City of La Porte Planning and Zoning Commission Agenda

Consider approval of a Major Development Site Plan (#14-83000003)
to allow for construction of an addition and other site improvements
for La Porte High School
located at 301 E. Fairmont Parkway.
Applicant: La Porte Independent School District

RE: Major Development Site Plan Application #14-83000003 (*Review of Submittal #3*)
La Porte High School – 10615 N. “L” Street

LA PORTE HIGH SCHOOL SITE PLAN

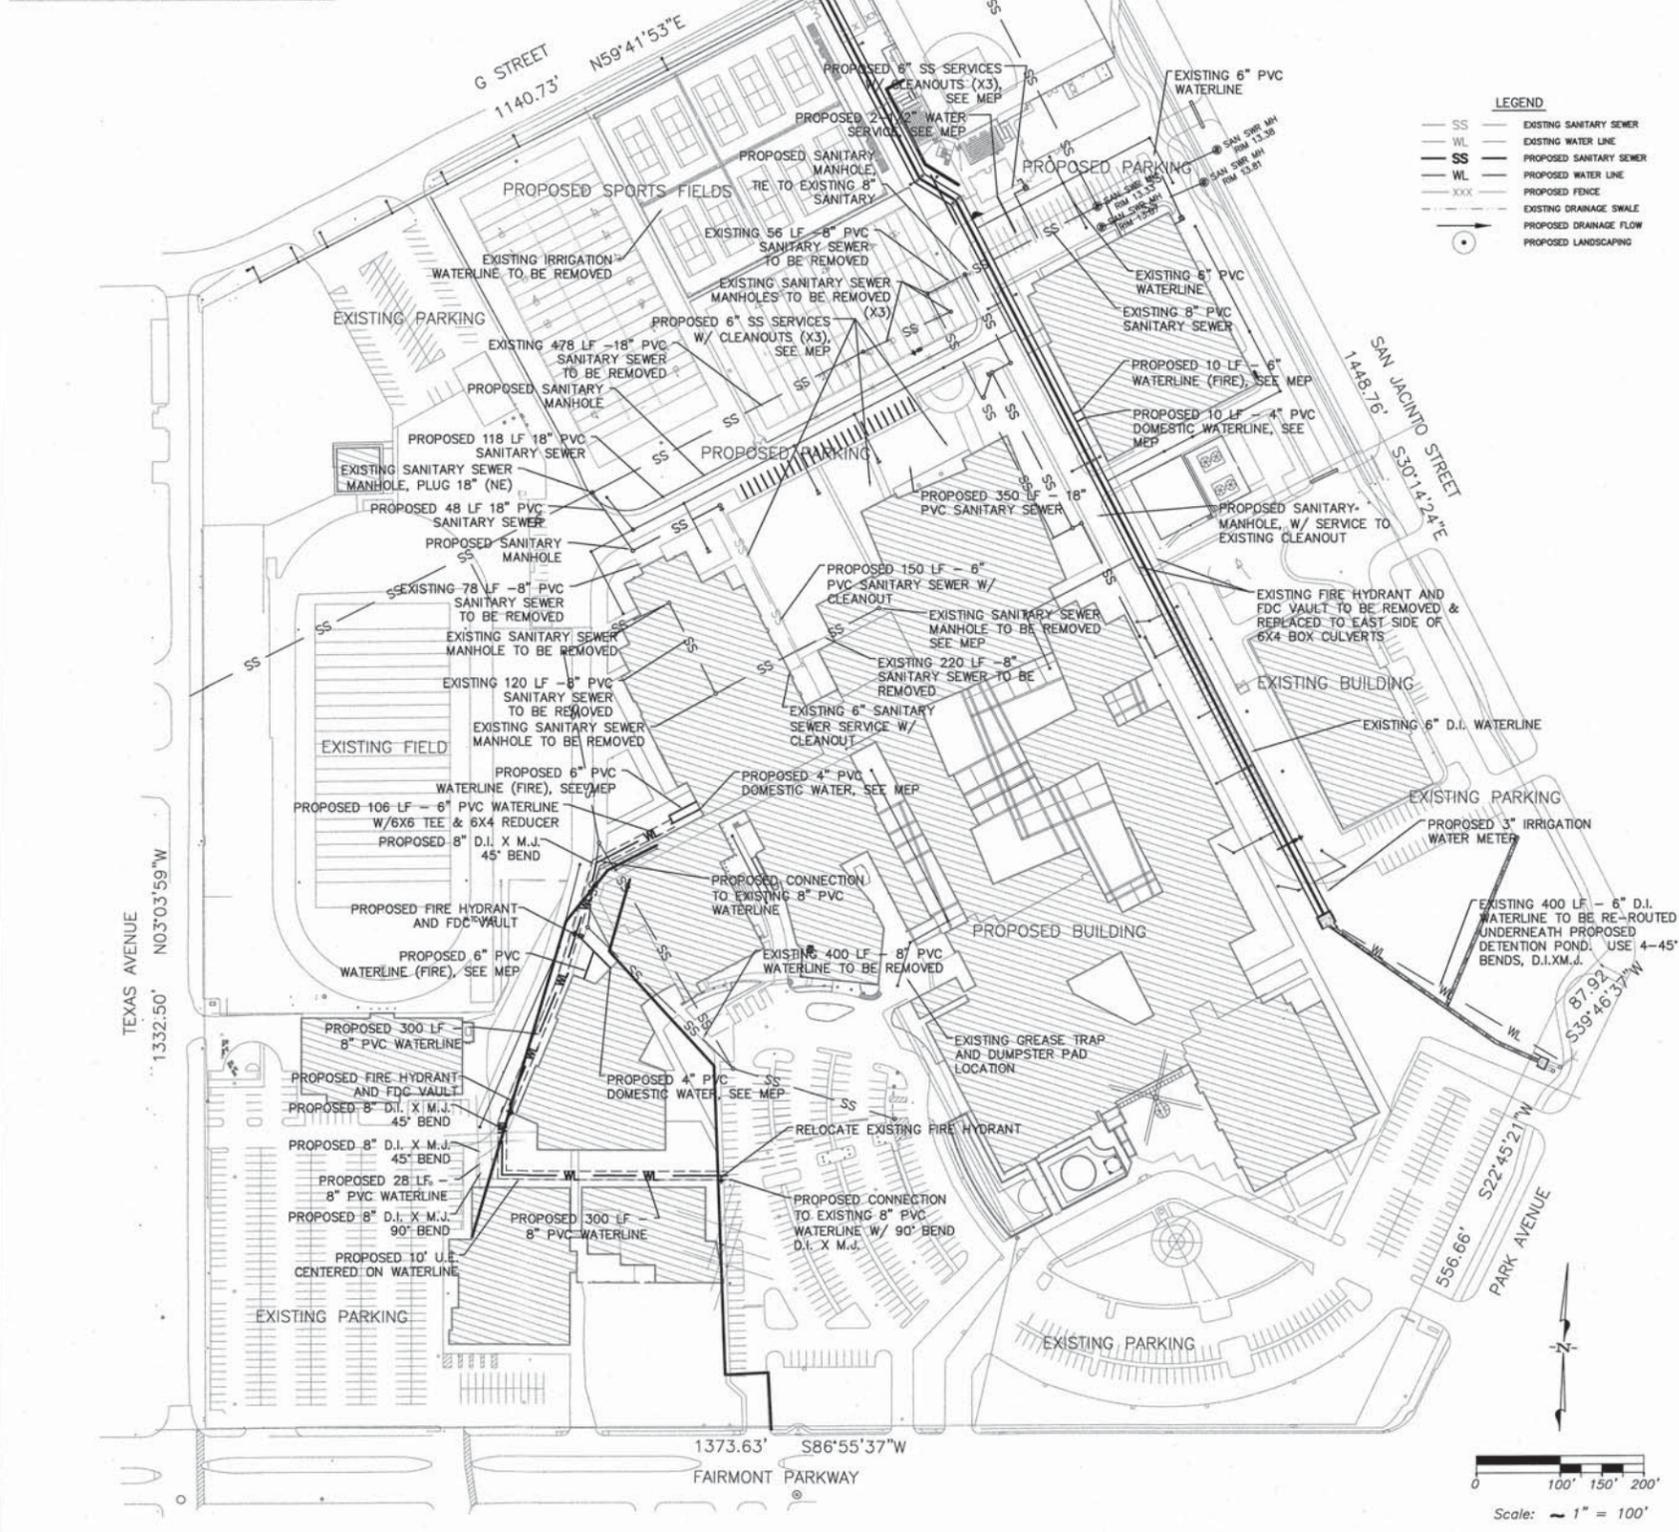
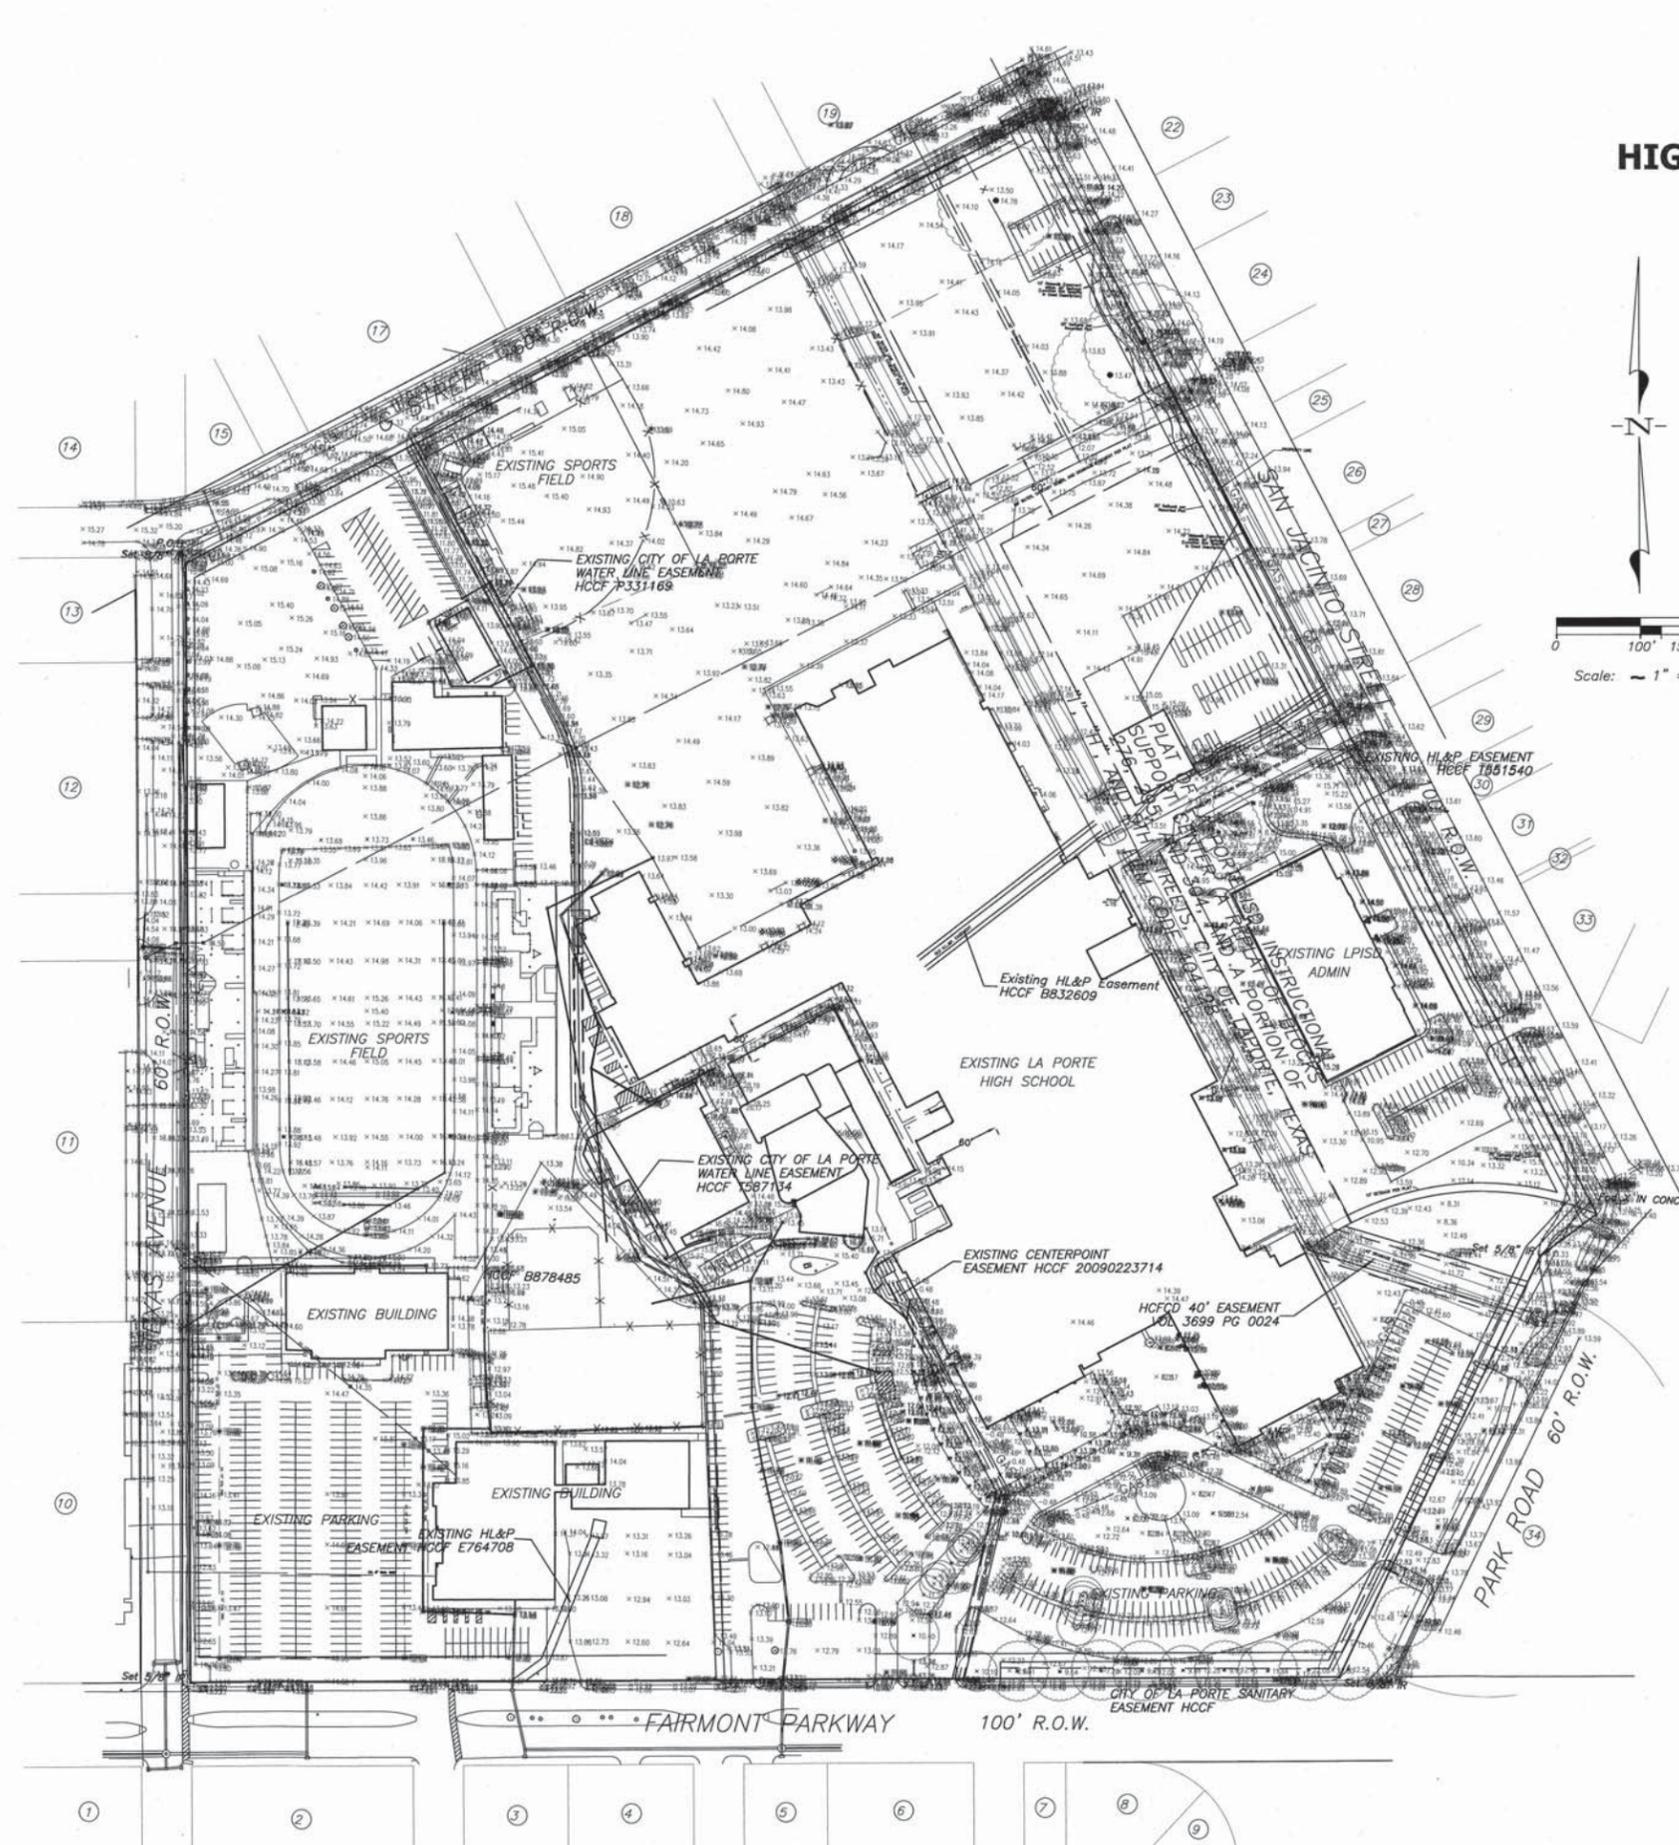
1. The plan included a note regarding the location of dumpsters, but this note will also need to include screening materials used for the dumpster.
2. The street trees need to be shade trees not ornamental trees.
3. Near the new entrance on San Jacinto, there is a reference to “8 Waxleaf Ligustrum” but I do not see where those plants are located. Please identify on the site plan.

13. Show and call out existing fire line and domestic water service for Administration Bldg.
14. Clarify and call out if sanitary sewer or manholes will be abandoned in place.
15. Contact Public Works for specifications regarding the proposed 3" and 4" domestic water meters and other meter installation requirements.
